UNITED STATES
NUCLEAR REGULATORY COMMISSION
WASHINGTON, D. C. 20555

Docket No. 50-295
and 50-304

RE: ENVIRONMENTAL QUALIFICATION OF ELECTRICAL EQUIPMENT

FIGURE 1

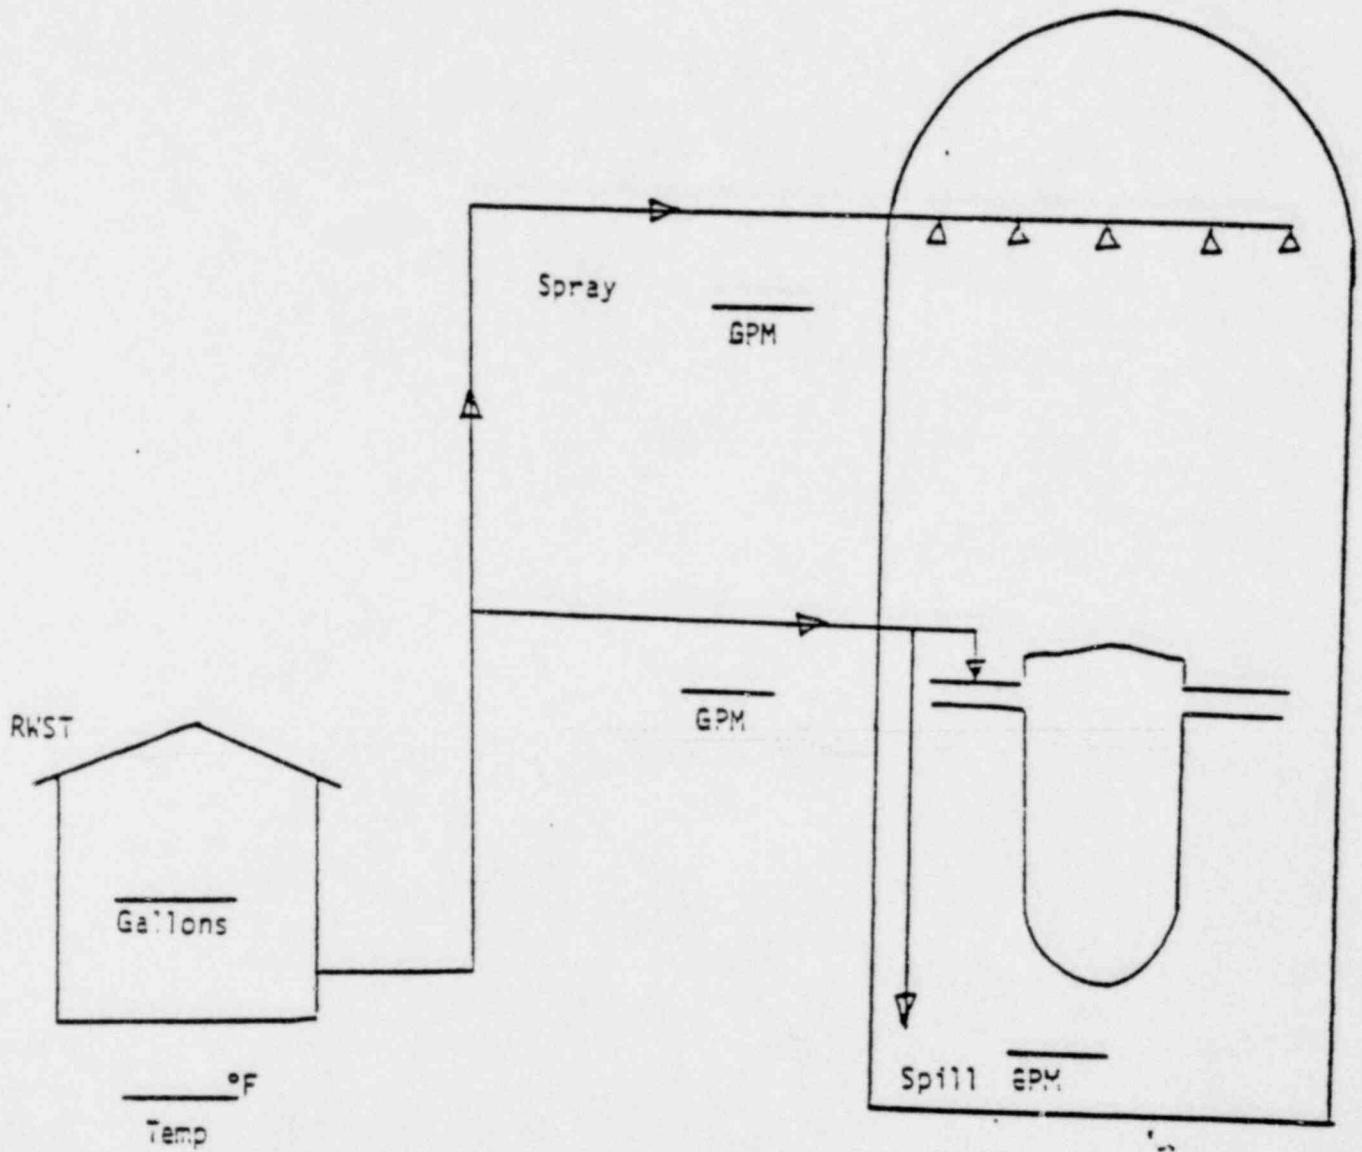
II. Figure 1 and 2 represent typical ECCS and spray systems relied on to mitigate the consequences of a pipe break. Provide the information indicated in the figures; if the plant specific systems differ from the attached figures, revise the drawings to represent your facility and provide the appropriate information.

FIGURE 1 - INJECTION PHASE

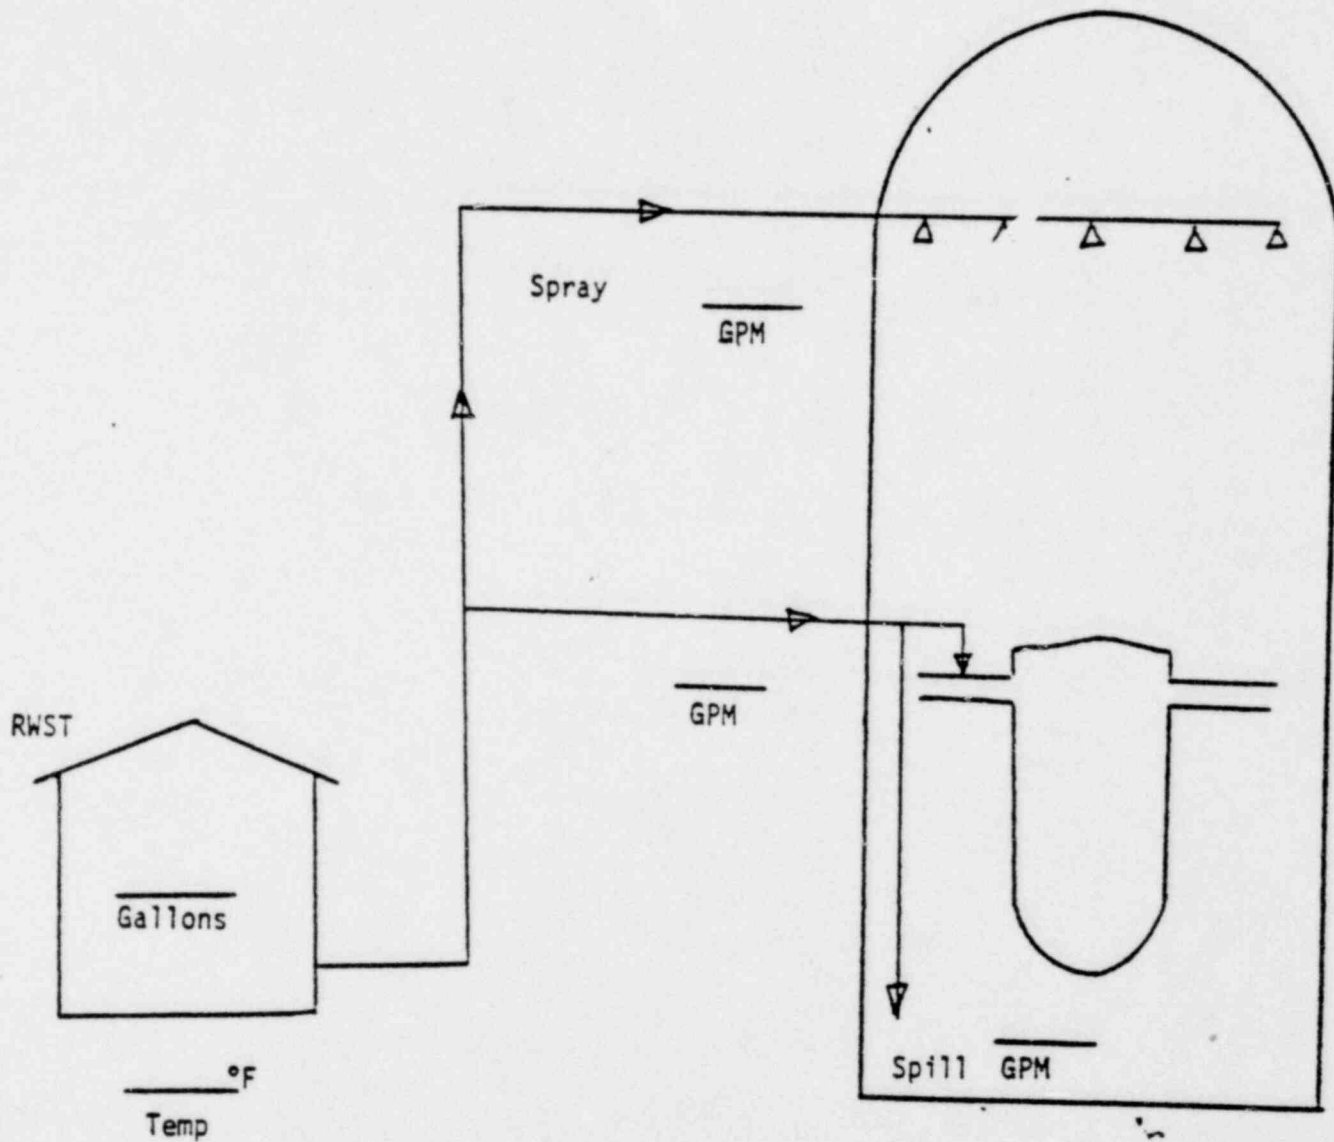
- I. When providing system parameters, indicate whether the values given assume a single failure and specify the single failure assumption.
- II. Figures 1 and 2 represent typical ECCS and spray systems relied on to mitigate the consequences of a pipe break. Provide the information indicated in the figures, if the plant specific systems differ from the attached figures, revise the drawings to represent your facility and provide the appropriate information.
